## 5 Government submissions

This chapter provides a summary and response to the eight local and State government submissions (including interagencies) received on the proposed modification.

### 5.2 Department of Planning and Environment

Figure 5.1

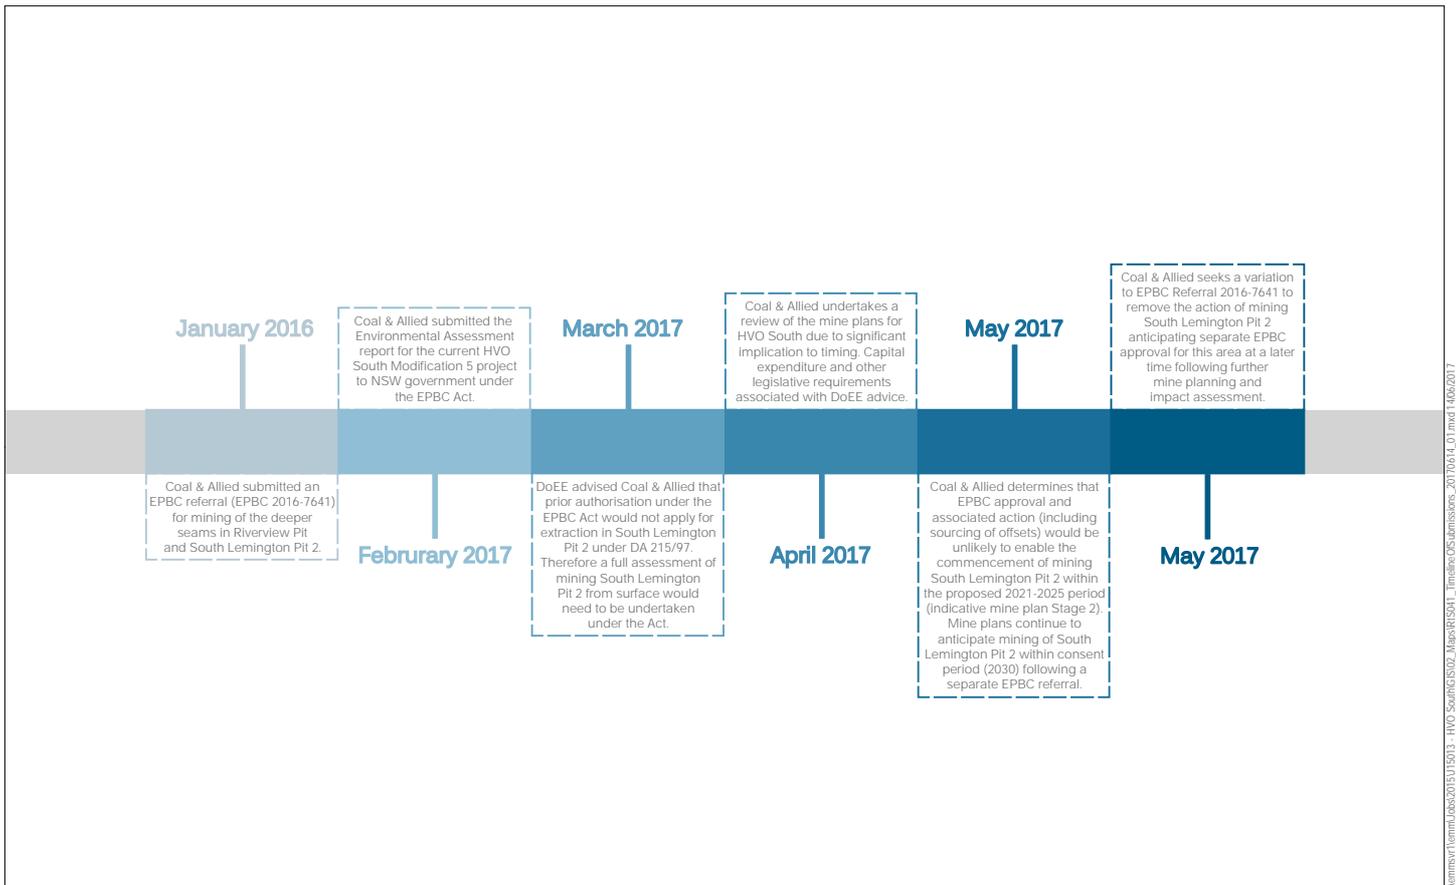
The DPE submission referenced Section 4.4.1 of the EA that stated two referrals had been lodged for HVO South. The DPE requested further information on the status of these referrals.

A letter of variation was submitted to DoEE regarding the proposed action. The letter of variation confirmed the proposed action only comprised the continuation of mining from Cheshunt Pit into the Riverview Pit to access the deeper Bayswater seam within the Riverview Pit area.

On 29 May 2017, DoEE approved the request to vary the proposed action.

The timeline of the assessment processes that have led to this position and the change of the scope for the referral compared with the proposed modification are shown in Figure 5.1.

Macro-relief within upper slopes of Cheshunt overburden emplacement area

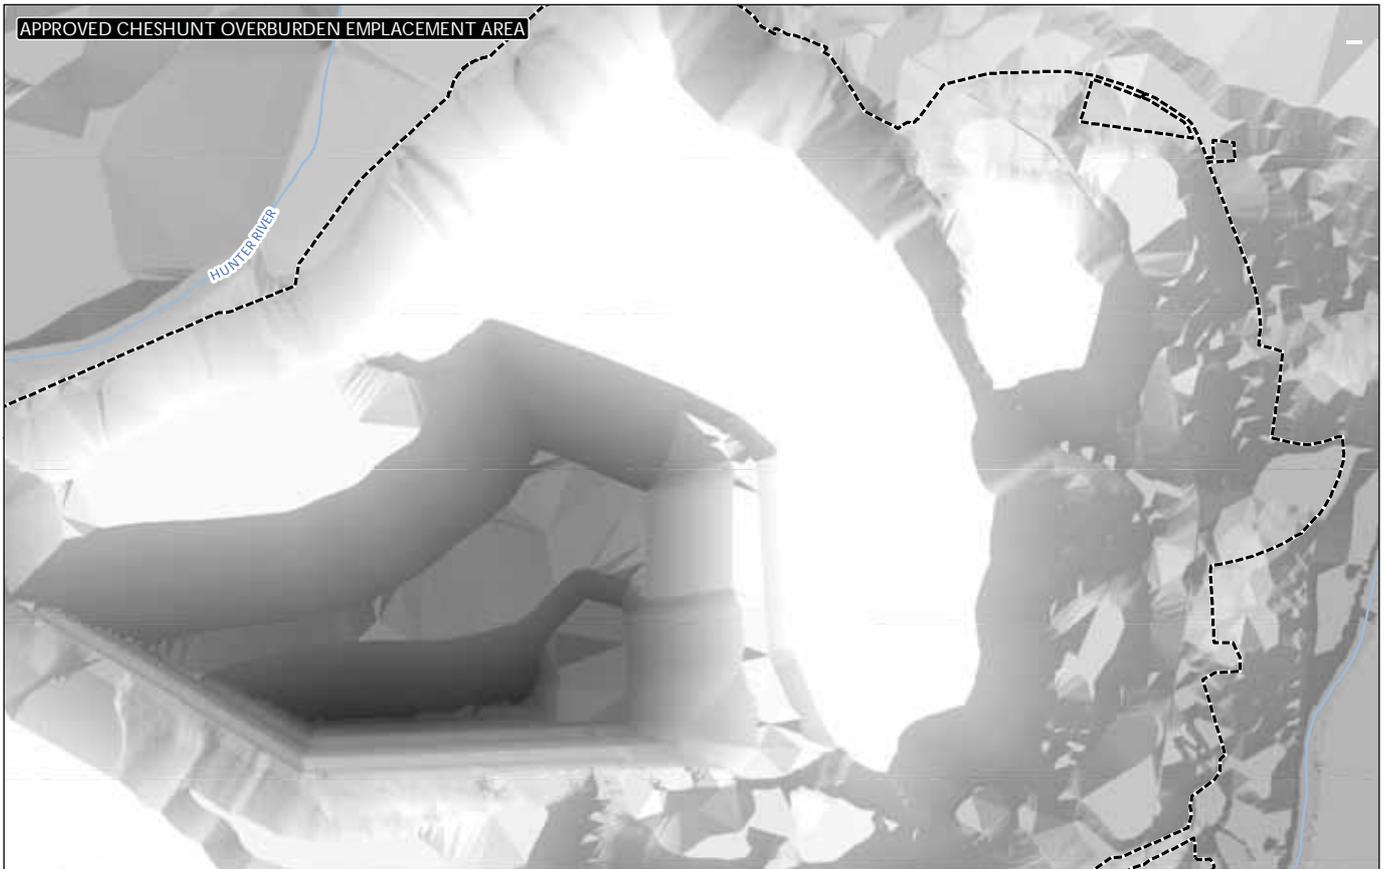
The DPE noted that the proposed design of the overburden emplacement area represents a substantial improvement to the traditional design and methods. The submission requested that Coal & Allied consider opportunities for further refinements, such as incorporating more topographic variation to the external slopes of the emplacement areas to improve visual amenity. DPE stated that the northern area of the Cheshunt overburden emplacement area appeared to have minimal macro-relief and may represent an opportunity for further refinement.

In response to the DPE request, Figure 3.3 of this RTS has been prepared to illustrate the stylised macro-relief at a 1:1 scale. Figure 5.2 has been prepared at a finer scale to assist with visualising the topographical relief in the northern area of the Cheshunt overburden emplacement area.

In addition to micro-relief, the proposed final landform also comprises some macro-relief within its design. Macro-relief of overburden emplacement areas is generally visible at distance rather than at closer proximity. This is shown in photomontages presented within the EA for viewpoints at Knodlers Lane (Figure 9.5) and Long Point (Figure 9.7), which are 3.6km and 7km from the Cheshunt overburden emplacement area, respectively. Viewers from Long Point are able to more readily view the macro-relief within the final landform than those in closer proximity at Knodlers Lane due to the increased setback.

Sediment dams under the proposed modification and approved operations  
 HVO South Modification 5  
 Response to submissions  
 Figure 5.3

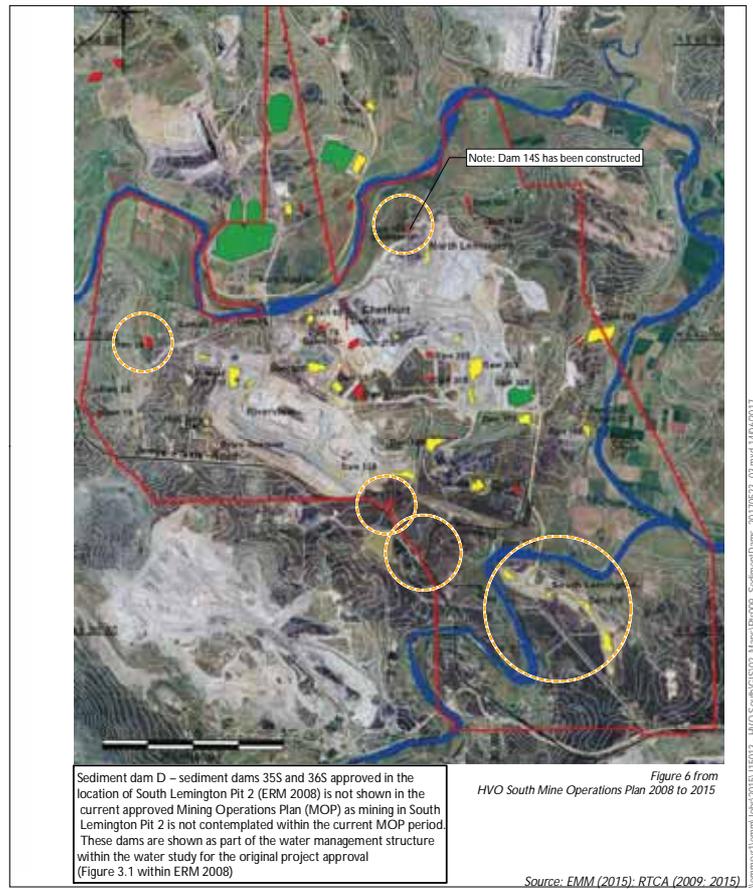
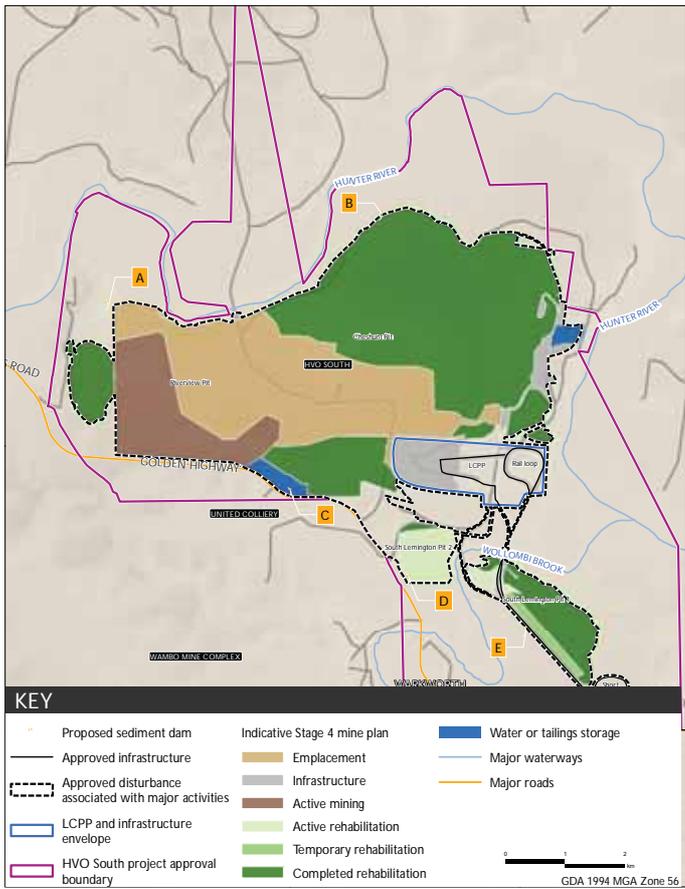
The sections below provide further information in response to DPI Water's matters raised regarding sediment dams under the proposed modification, surface water extractors, clean water diversions and the final landform catchment areas.

These structures (as presented in the proposed modification) perform the same function as structures previously presented in the approved mine plan and the approved Mining Operations Plan (MOP). This is shown in Figure 5.3 and described in Table 5.4 below.

The design, implementation and operation of sediment dams at HVO South will continue to occur in accordance with currently approved WMP (RTCA 2015).

Maximum additional drawdown due to proposed modification - Quaternary alluvium  
 HVO South Modification 5  
 Response to submissions  
 Figure 5.5

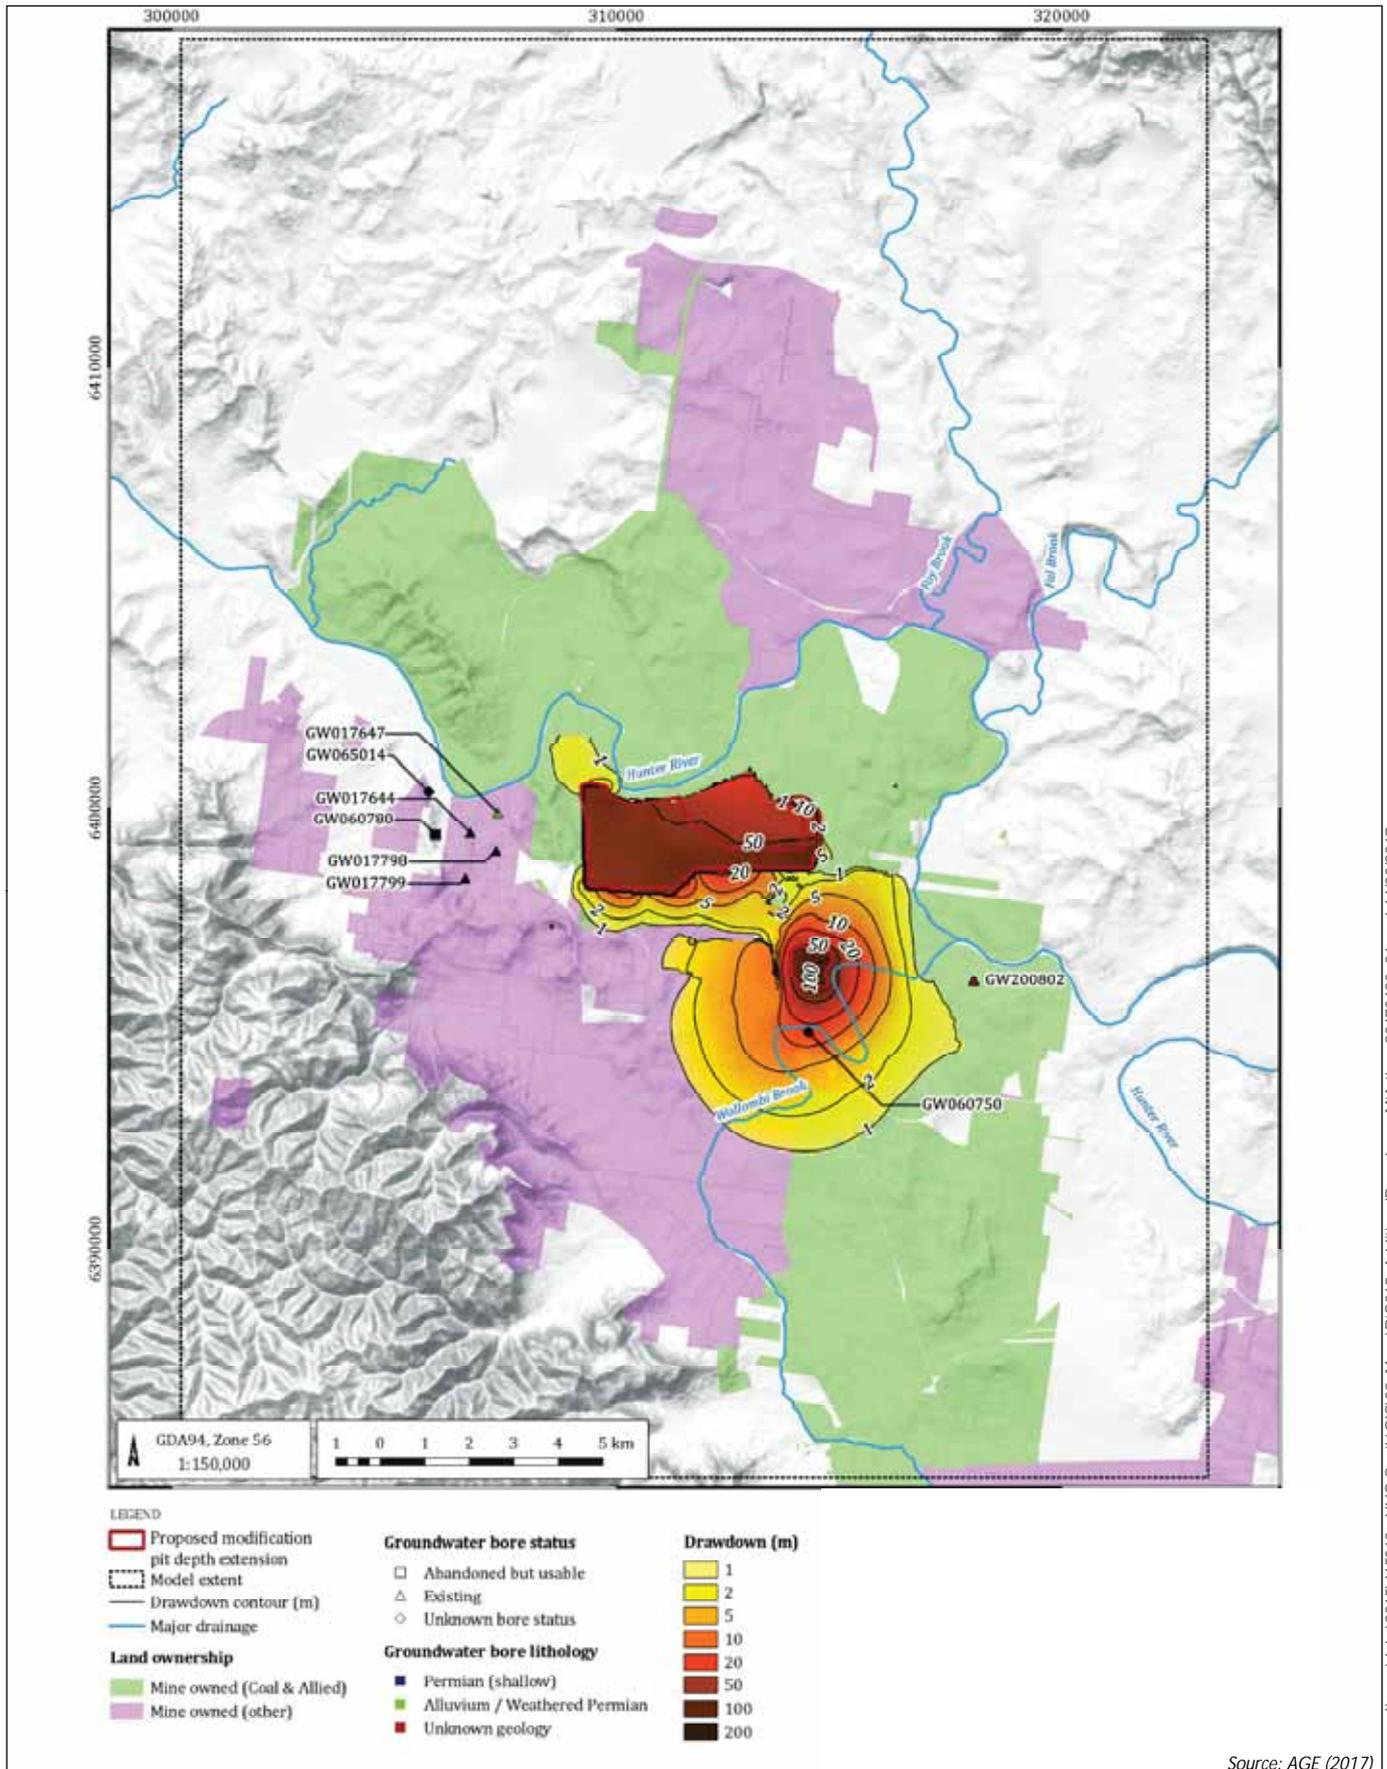
The DPI Water submission requested that Figure 10.3 of the EA (groundwater users) be updated to include all 43 bores surveyed, be colour coded to show different categories of bores and the target aquifers and include predicted drawdown contours. The submission also requested further information on the incremental drawdown on private extractors, including updating the relevant figures displaying drawdown to include surveyed bore and lithology details. These requests are addressed in the sections below.

Figures 5.5 to 5.7 present the predicted groundwater level drawdown in the Quaternary alluvium, shallow Permian coal measures (Mt Arthur Seam) and deeper Permian coal measures (Bayswater Seam) due to the proposed modification. Figures 5.8 to 5.10 present cumulative drawdown predictions for the three stratigraphic sequences. Each drawdown figure includes private bores that likely occur within the relevant lithology, which has been assessed based on available bore details (ie screened lithology and bore depth) and mapped geology. Full details about each private bore are in Table A-5 of the groundwater study within Appendix G of the EA.

Figure 5.5 shows that no private bores will experience a drawdown due to the proposed modification within the alluvium in excess of 1m. As shown in Figure 5.8 and discussed in Chapter 10 of the EA and the technical study (Appendix G of the EA), there is one bore (10011459) on land owned by Glencore (Ravensworth Mine) with a bore depth of around 12m with predicted drawdown due to the proposed modification and with cumulative drawdown of greater than 2m. The decline is predominately due to the cumulative impact of the approved and surrounding operations, with the proposed modification only contributing 0.3m of additional drawdown.

Representative receptors and INP modifying factors  
HVO South Modification 5  
Response to submissions  
Figure 5.12

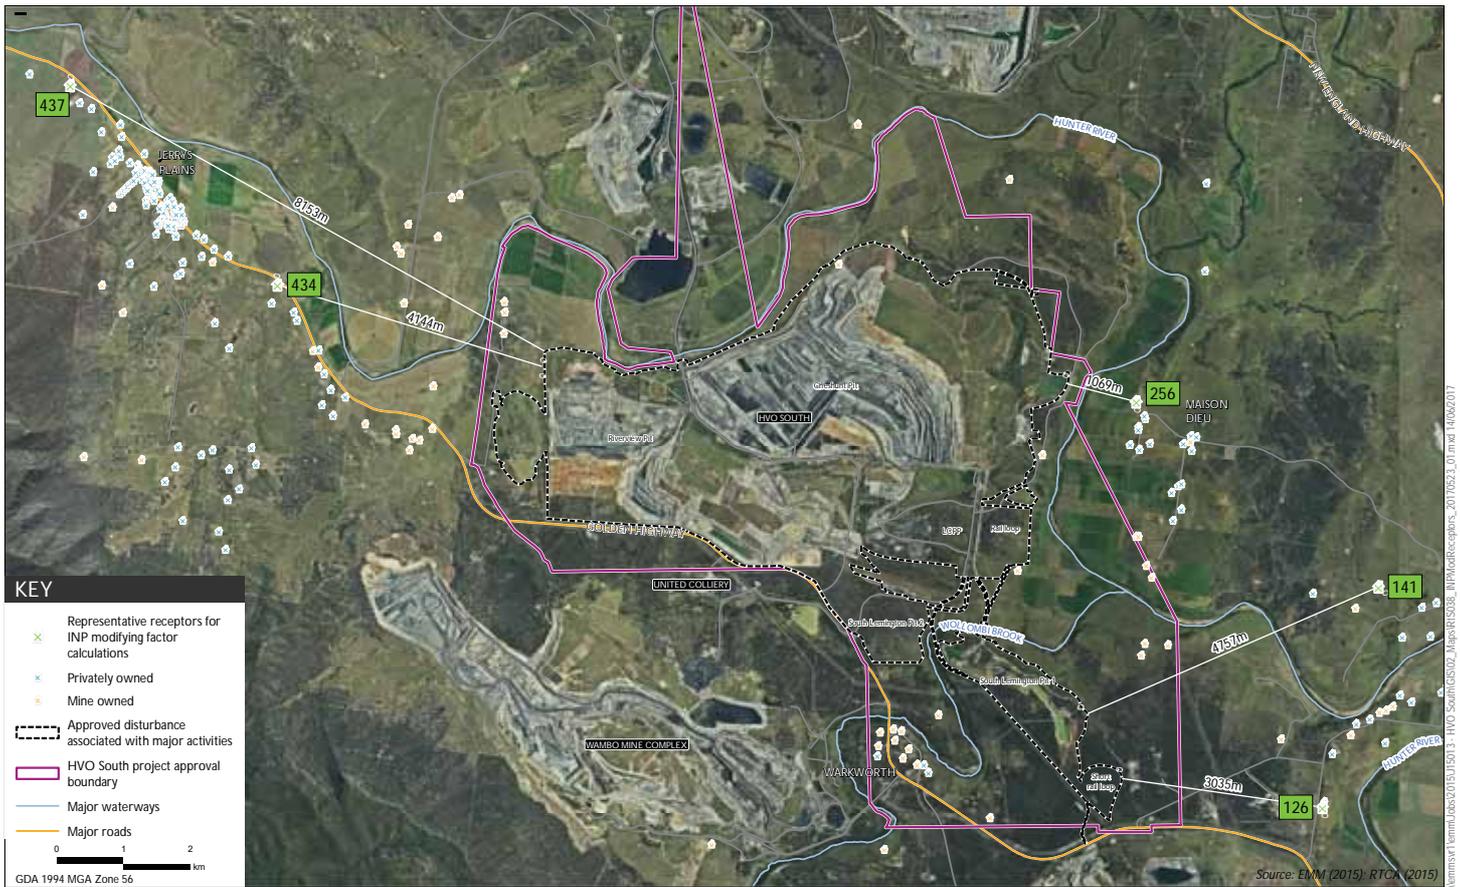
An example of why the INP method is not appropriate in these situations is demonstrated through the modelling results for assessment location 434 shown in Table 5.6 (refer also to Figure 5.12). The predicted A-weighted noise level at assessment location 434 is above the corresponding criterion value and adding a 5dB penalty as per the INP would result in a perverse outcome as this would result in a higher predicted noise value for a location further away from HVO South (over 4km away compared to 3.2km for assessment location 256).

Another relevant test is that recommended by Broner (2011) technical paper which sets a minimum (night time) limit for residences of 60dBC before impact from low frequency noise is expected to commence. As shown in Table 5.6, predicted C-weighted noise levels are well (at least 7dB) below 60dBC.

Water Balance Model Schematic  
 HVO South Modification 5  
 Response to submissions  
 Figure 5.13

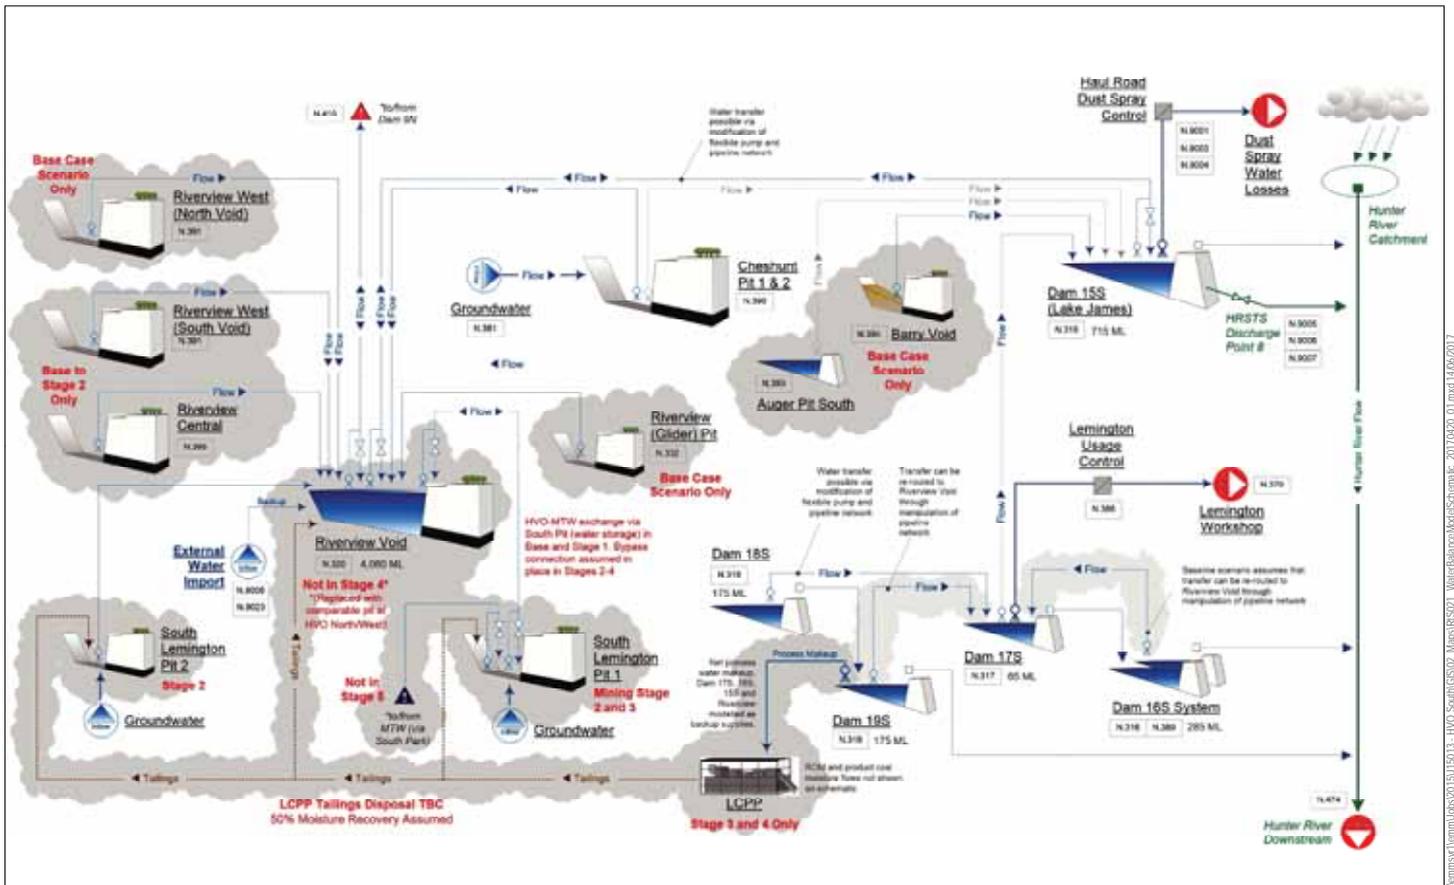
The EPA submission noted that the Water Balance Model Schematic Figure 6.1 within the water balance study was unclear. The EPA noted that the study did not comprise an assessment of pollutants in the discharge from these sediment dams.

A high resolution version of Figure 6.1 from the water balance study is provided as Figure 5.13.
